Staff Summary Report

Development Review Commission Date: 11/27/07

SUBJECT: Hold a public meeting for a Development Plan Review for CARINO'S ITALIAN GRILL, located at 31 S. McClintock Drive in the Tempe Marketplace.

DPR07219 – Development plan review including building elevations, site plan and landscape plan for a one-story restaurant.

EXTERIOR ELEVATIONS

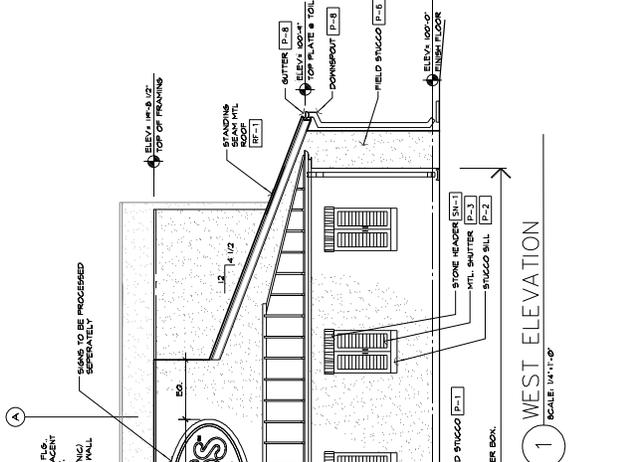
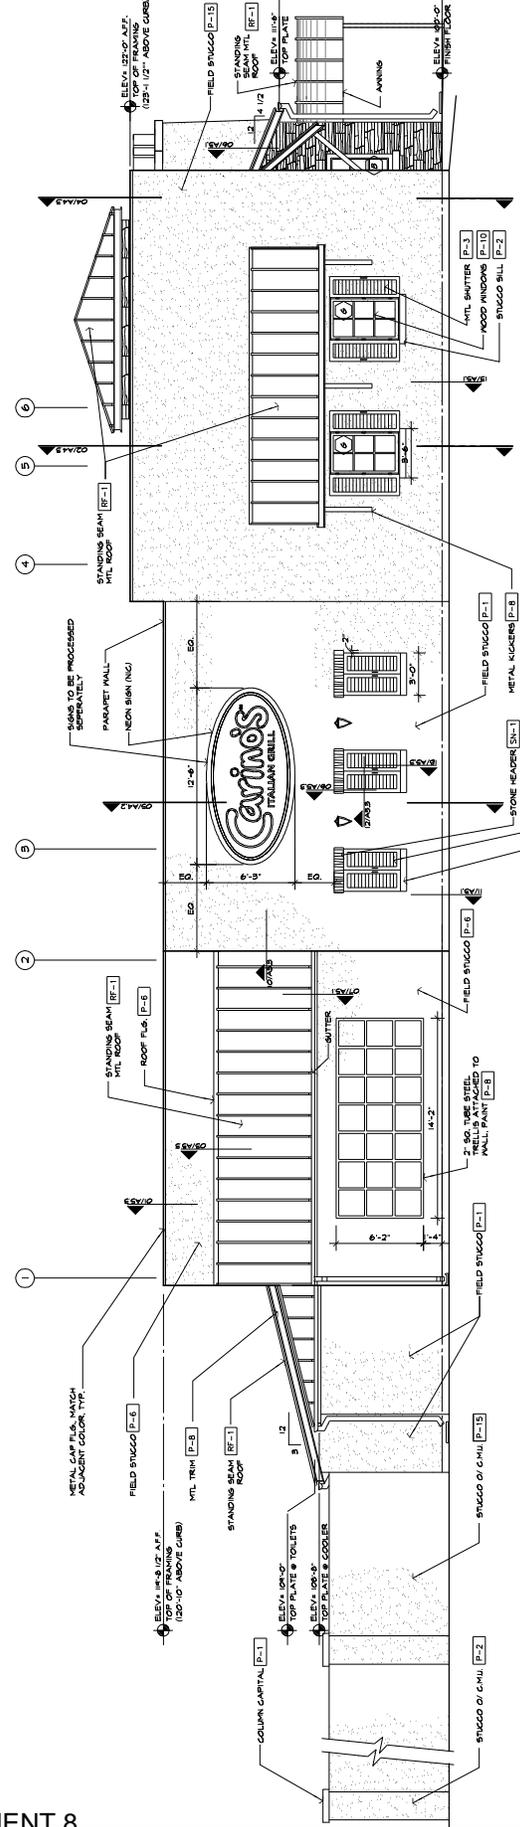
5. The materials and colors presented are approved as presented:
 - a. Roof – Flat parapet roof and Standing Metal Seam painted Sherwin Williams SW2124 *Stone Cutter*

- b. Metal gates at trash enclosure - painted to match adjacent stucco.
 - c. Primary building – Stucco field over CMU block walls and flashing sloped roof to parapet Sherwin Williams Superpaint, Satin SW2201 *Golden Gate* and SW2292 *Wild Rose* and SW2331 *Golden Buff*

- d. Accent building colors - Trim/sill coping, column caps, flashing sloped roof to stone, Sherwin Williams Superpaint, Satin SW2173 *Shaker Red*
 - e. Trellis and railings for patio - exterior metal paint siliconized enamel semi-gloss Sherwin Williams SW2124 *Stone Cutter*

- f. Accent building materials - Herringbone pattern synthetic brick and Lone Star Cultured Stone, *Ledgestone* style, *Apache* color
 - g. Window metal frames and mullions – Alkyd DTM Semi Gloss Sherwin Williams 6099 *Sand Dollar*

- h. Window panes - clear glass
 - i. Window shutters - metal painted Sherwin Williams Superpaint, Satin, SW2229 *Audubon Green*
 - j. Doors & trim – All exterior doors Siliconized Alkyd Gloss Sherwin Williams SW2808 *Rockwood Dark Brown*

Provide main colors and materials with a light reflectance value of 75 percent or less. Specific colors and materials exhibited on the materials sample board are approved by planning staff. Submit any additions or modifications for review during building plan check process. Planning inspection staff will field verify colors and materials during the construction phase.

6. Provide secure roof access from the interior of the building. Do not expose roof access to public view.
7. Conceal roof drainage system within the interior of the building. Minimize visible, external features, such as overflows, and where needed design these to enhance the architecture of the building.
